Addendum No. 6

PROJECT NO. 161026-00

PROJECT TITLE: Renovate Plant Science Building - Phase 2

DATE: **November 19, 2026**

1 MECHANICAL SECOND FLOOR PIPING PLAN - PHASE 2
1/8" = 1'-0"

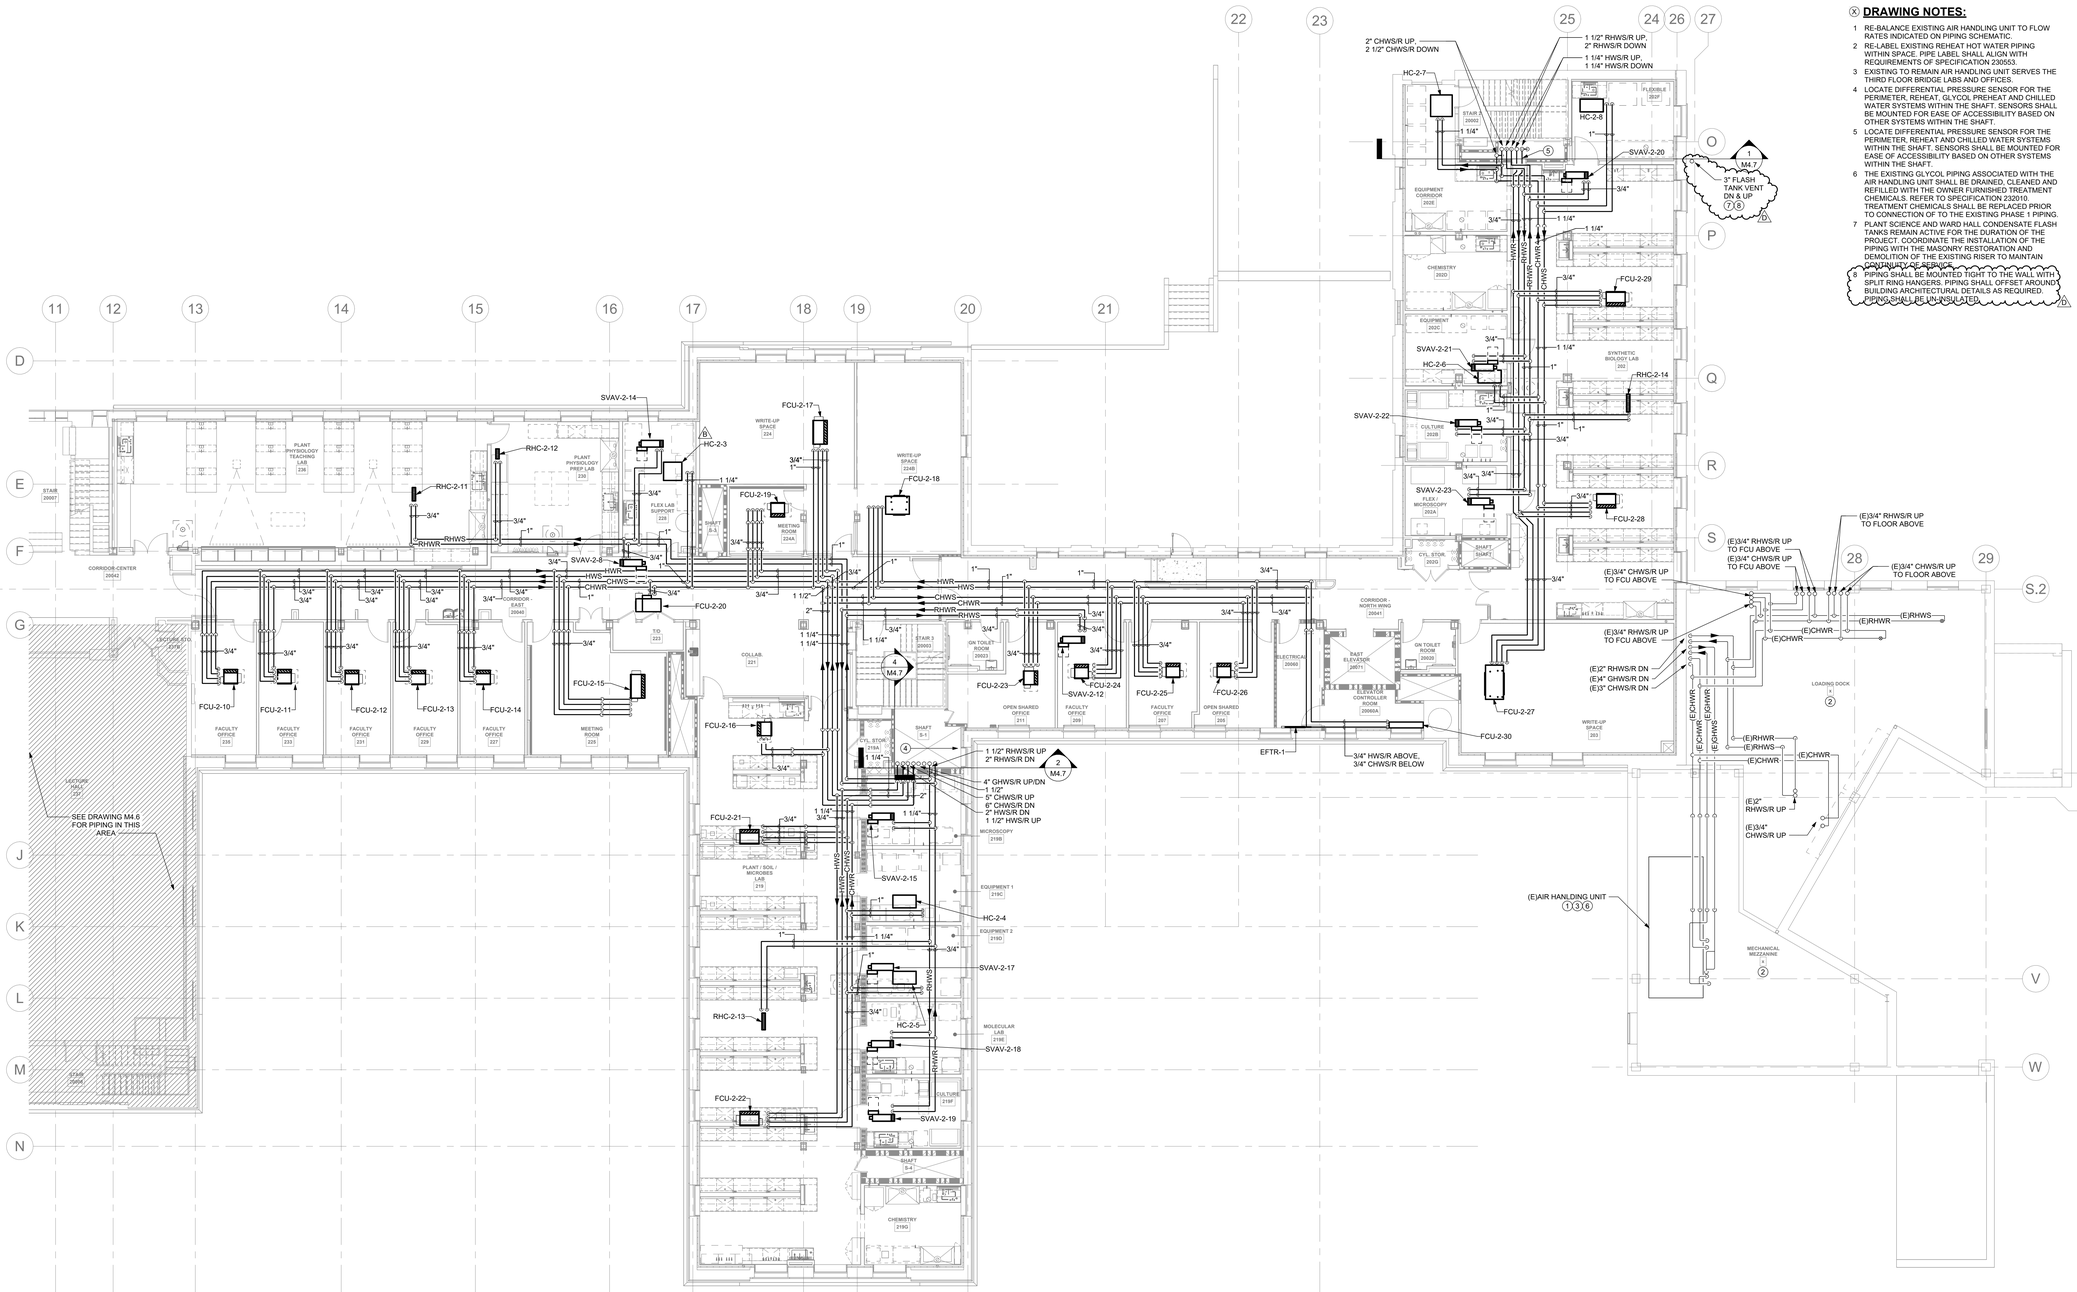
6.2bd: M2.2 – ADDED 3" Flash Tank Venting. ADDED Drawing Note 7 and 8.

1 MECHANICAL FOURTH FLOOR PIPING PLAN - PHASE 2
1/8" = 1'-0"

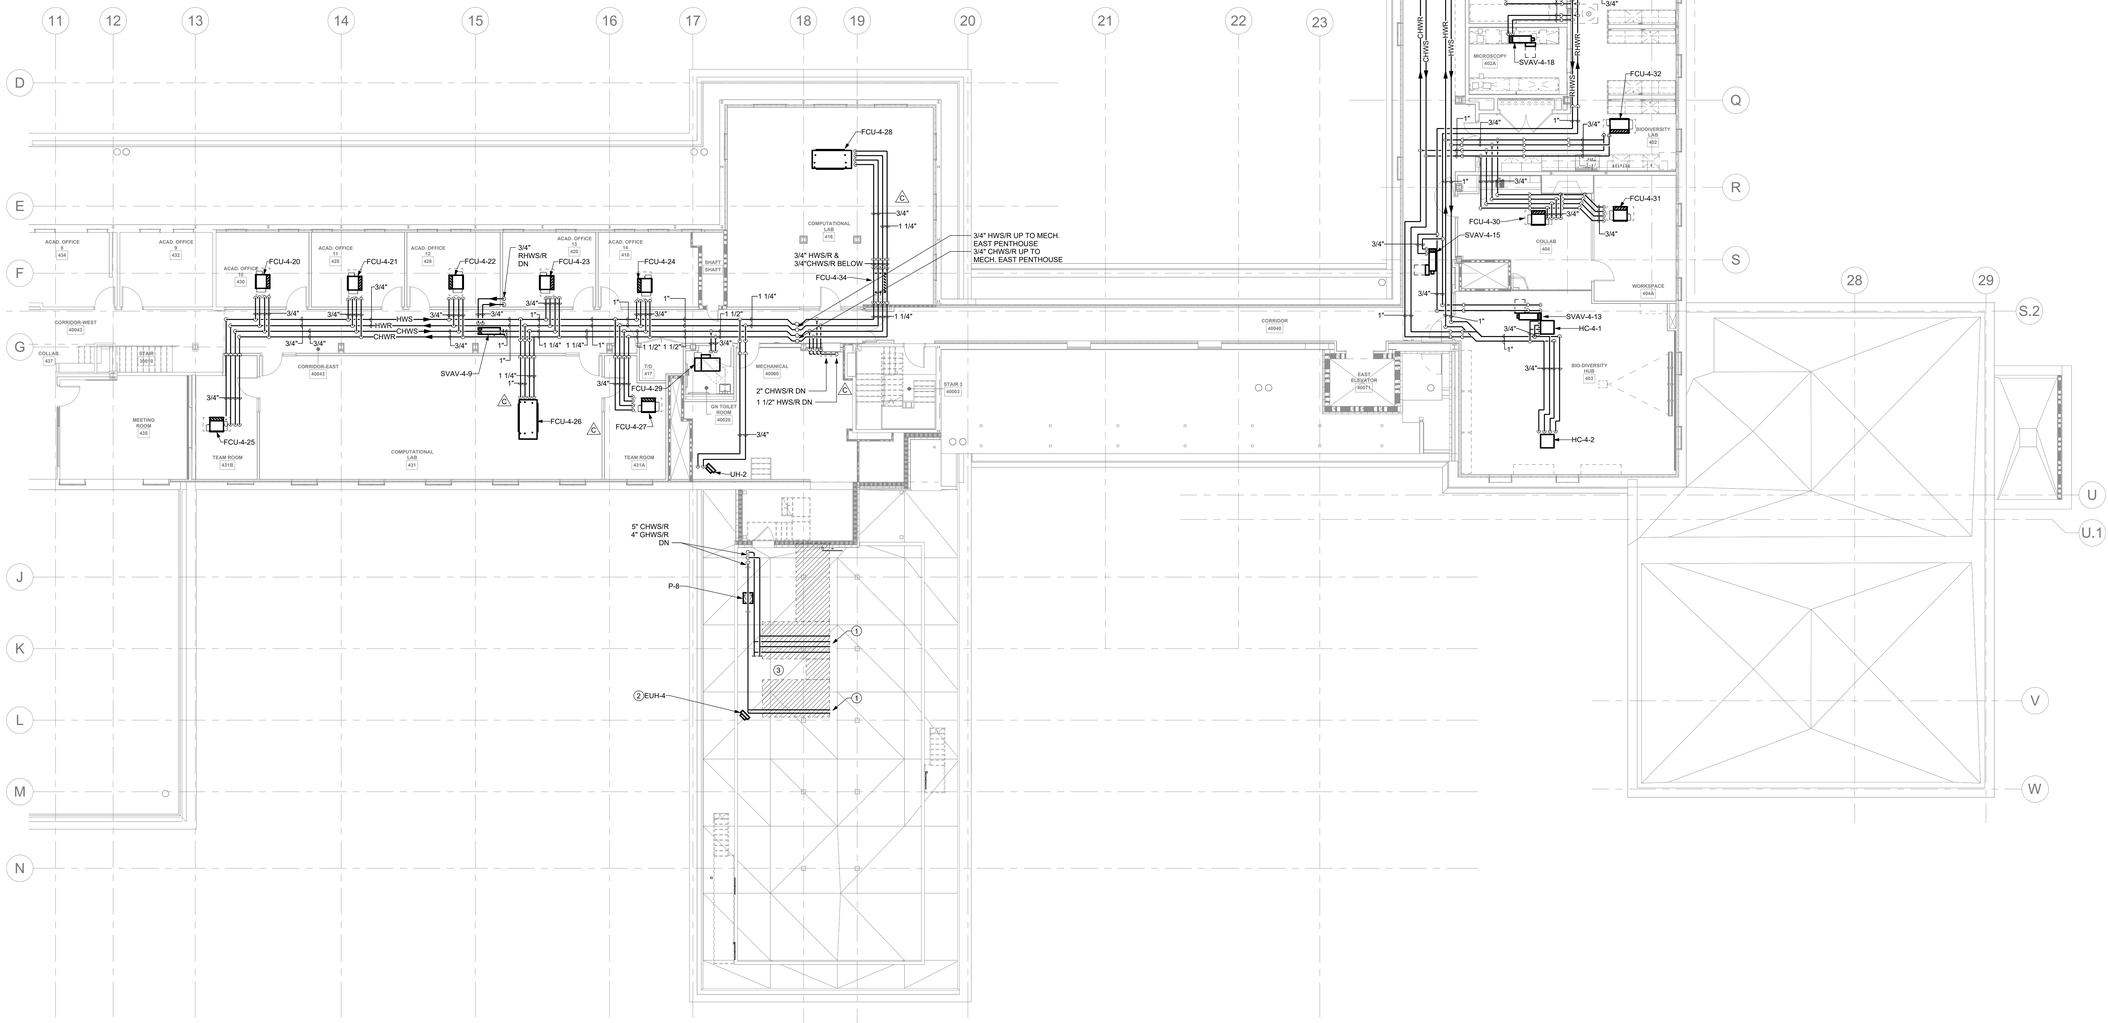
6.2bf: M2.4 – ADDED 3" Flash Tank Venting. ADDED Drawing Note 4 and 5. REVISED 1 1/4" CHWS/R to 1 1/2" to CHWS/R.

1 MECHANICAL HOT WATER FLOW DIAGRAM - EAST WING

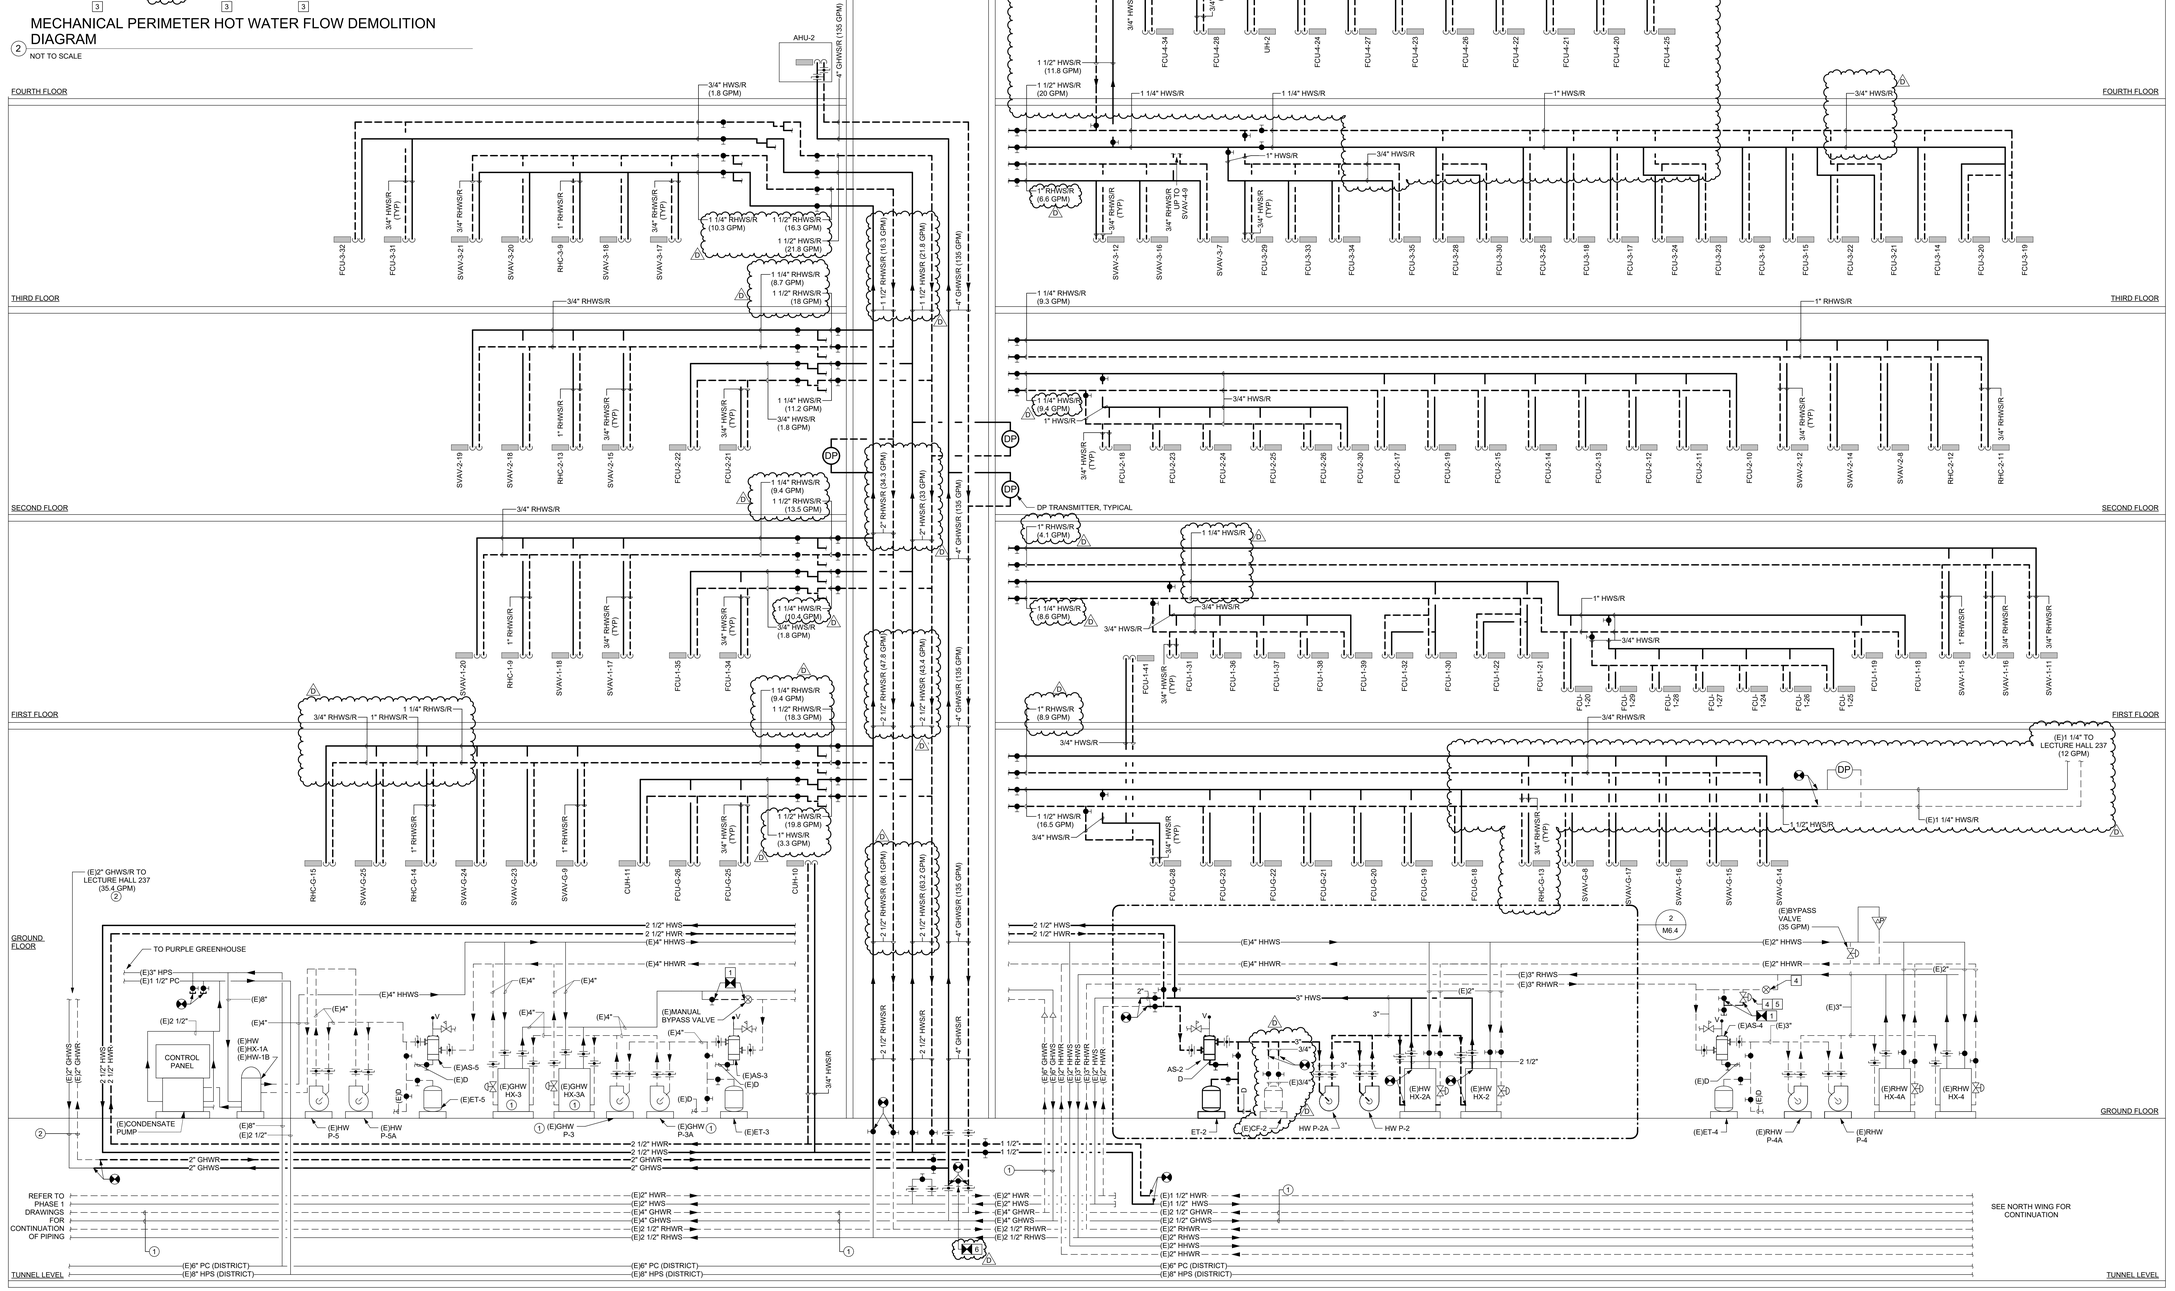
6.2bn: M6.4 – REVISED piping sizes, flow rates, configuration and equipment locations for HWS/R system. Revised piping sizes and flow rates for RHWS/R system. ADDED Demolition Note 6 and 7.

1 MECHANICAL HOT WATER FLOW DIAGRAM - NORTH WING
NOT TO SCALE

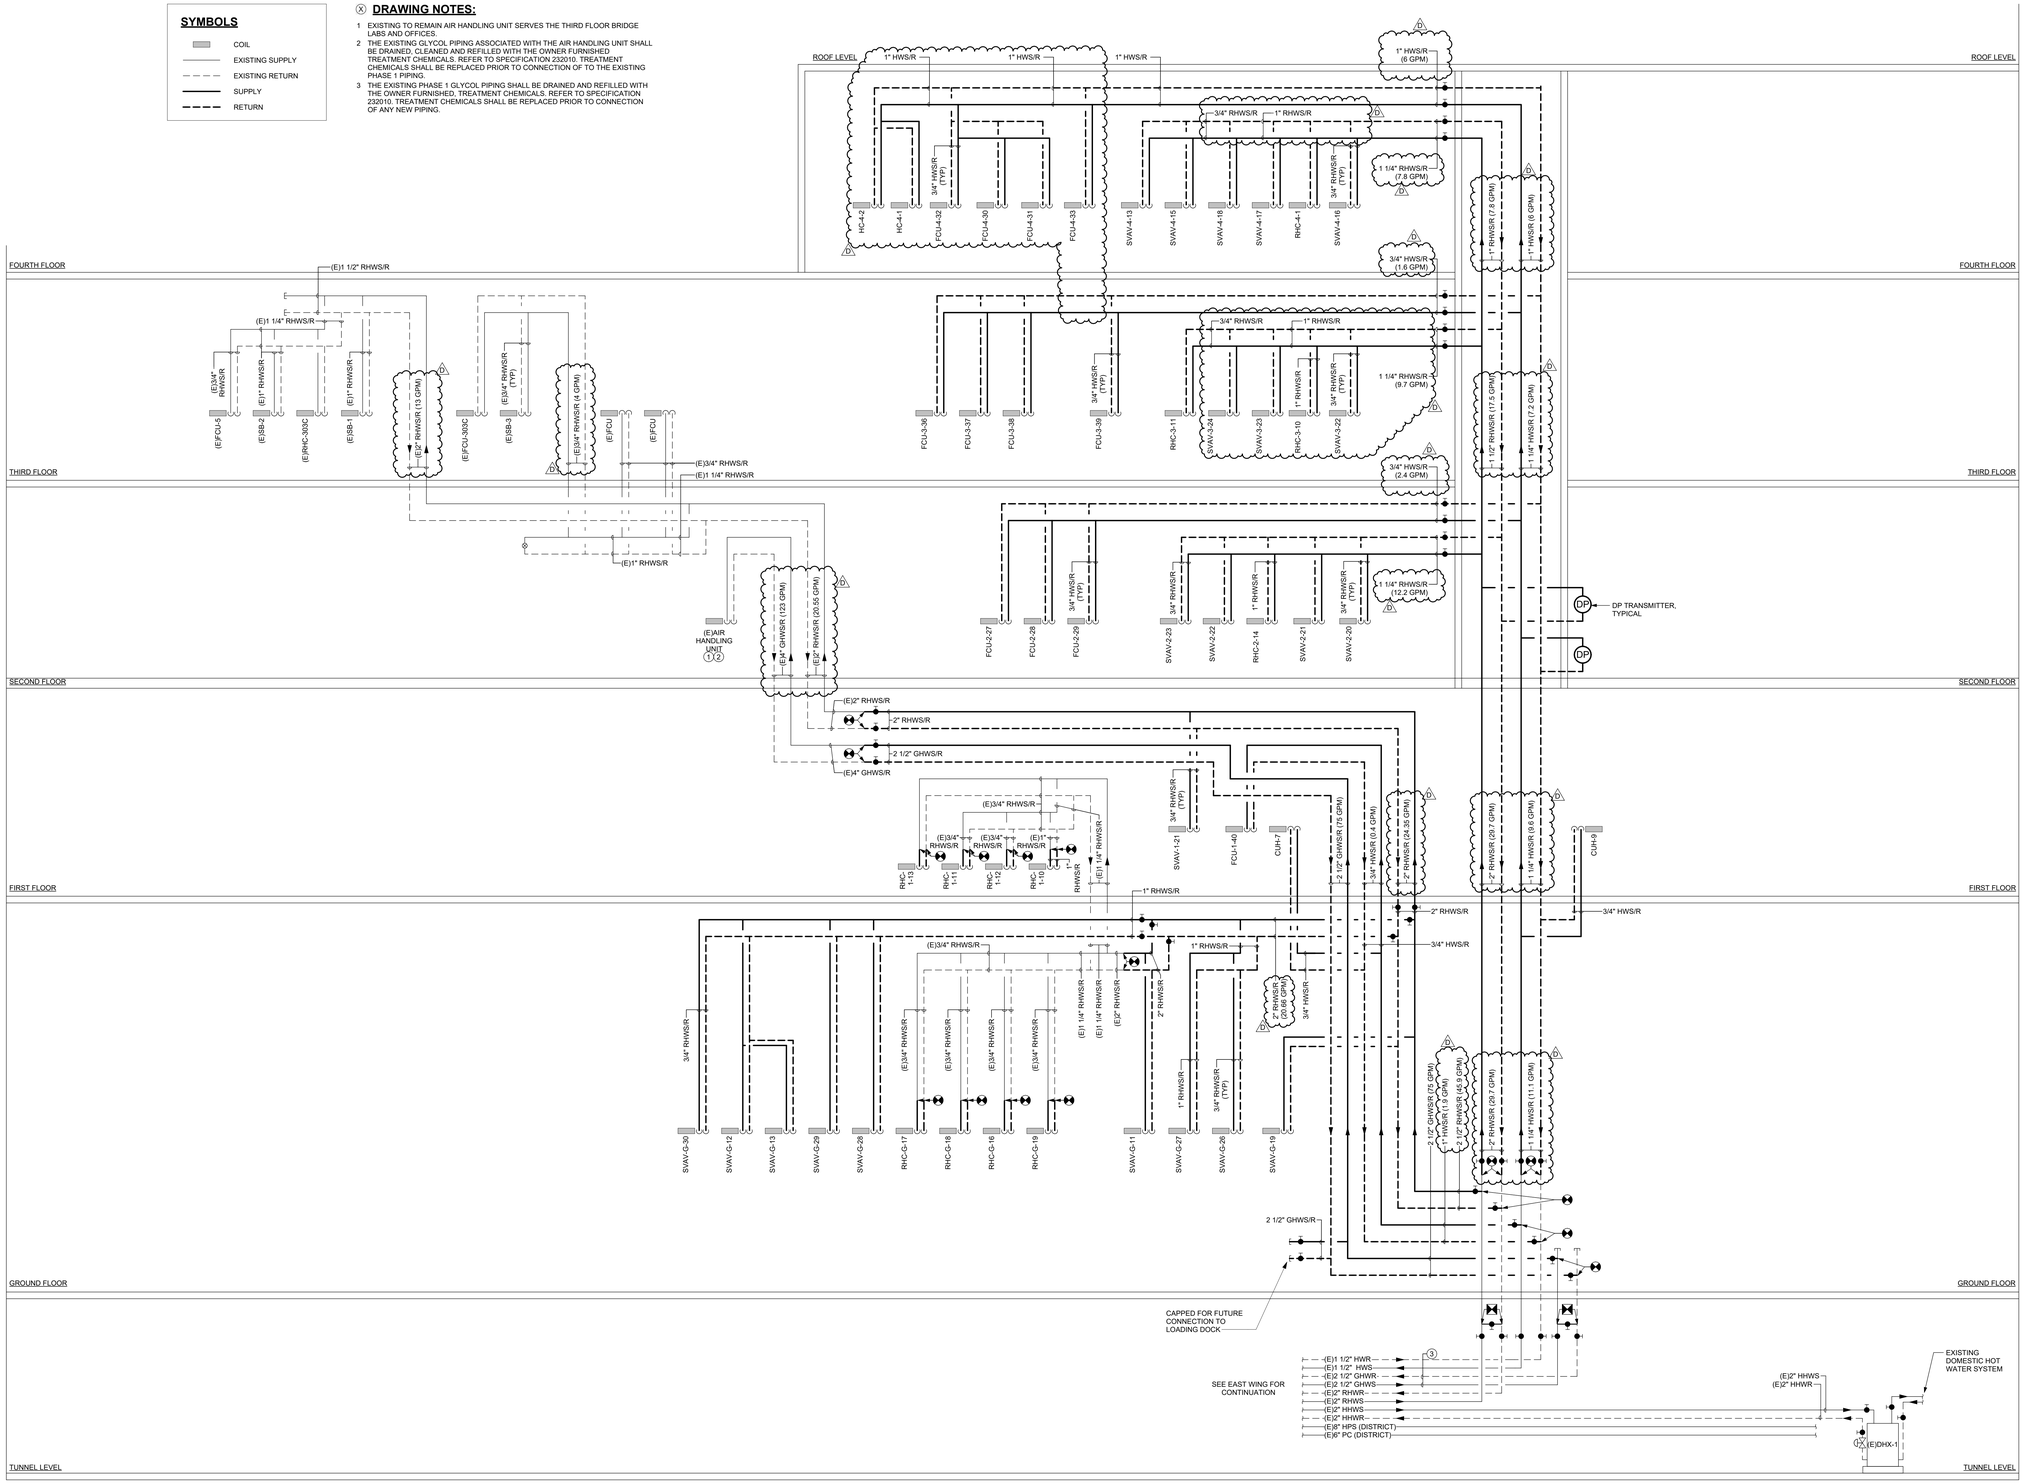
6.2bo: M6.5 – REVISED piping sizes, flow rates, configuration and equipment locations for HWS/R system. REVISED piping sizes and flow rates for RHWS/R system. ADDED flow rates for RHWS/R system.
